ISSUE: Permit to Demolish/Capsulate (partial) and Certificate of Appropriateness for alterations

APPLICANT: Timothy M. and Laura R. Biddle

LOCATION: Old and Historic Alexandria District
112 Cameron Mews

STAFF RECOMMENDATION

A101

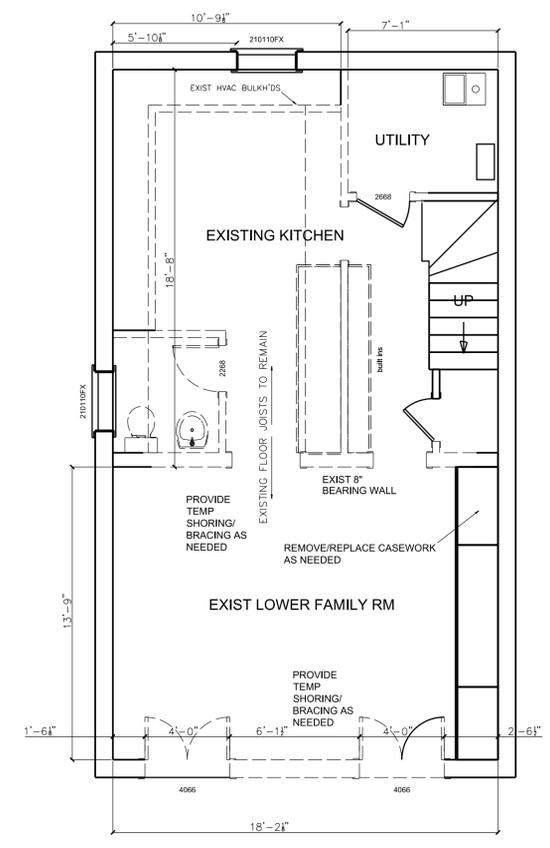
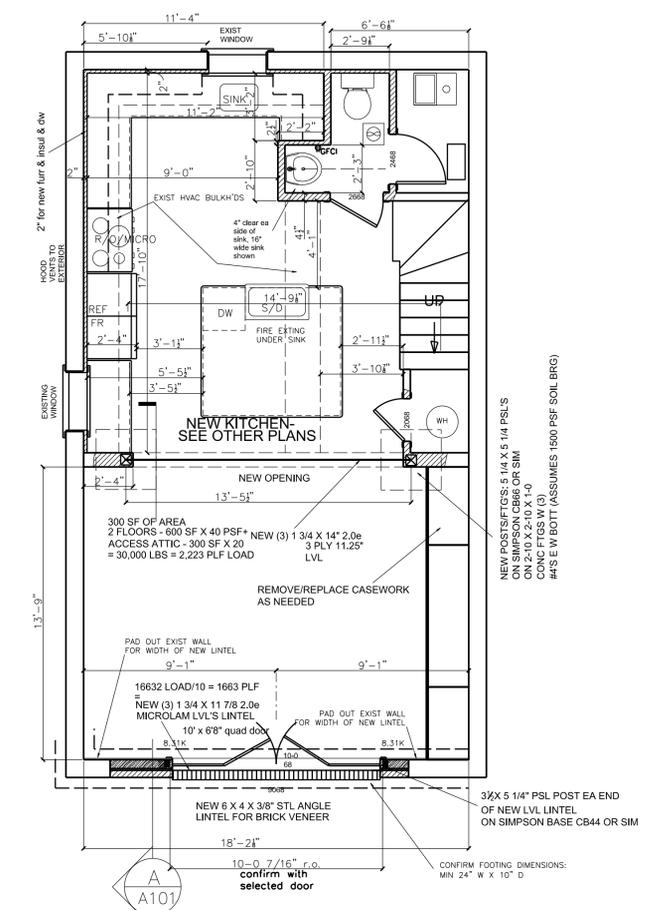
1. That the doors comply with the *Alexandria New and Replacement Window Performance Specifications in the Historic Districts*
2. That the new brick-clad lintel has the same jack arch with keystone design as the existing

The project proposes to remove the two existing sets of French doors (Figure 1) and install four Windsor Aluminum Clad, Low-E 366, Full Light doors, two operable at the center flanked by two stationaries. A new lintel clad with brick veneer will be added on top of the new opening.

Furthermore, the existing doors feature jack arches with keystones, a stylistic feature on the Colonial Revival townhouse that are visible from Cameron Street. Thus, staff recommends that this architectural feature be incorporated into the new design.
